From: Eric Thornsbury
To: Lois, Erasmia; Yerokun, Jimi
Date: 12/20/05 6:56AM
Subject: HRA Comments

TO: Eric Thornsburg, ACRS Staff Engineer
FROM: George Apostolakis, ACRS Member
RE: Focus of Human Reliability Analysis

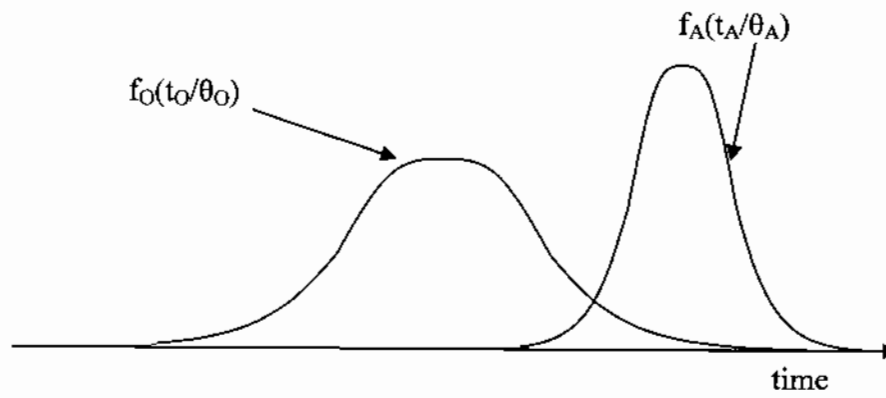
g. To better understand eq. (2), we look at the following picture:

- h. This picture shows the aleatory curves only. The double integral in the brackets of eq. (2) is the probability that $T_O > T_A$. To get the complete picture, imagine that each of the above curves is a member of a family of curves that are indexed according to the epistemic distributions $\pi_O(\theta_O)$ and $\pi_A(\theta_A)$.
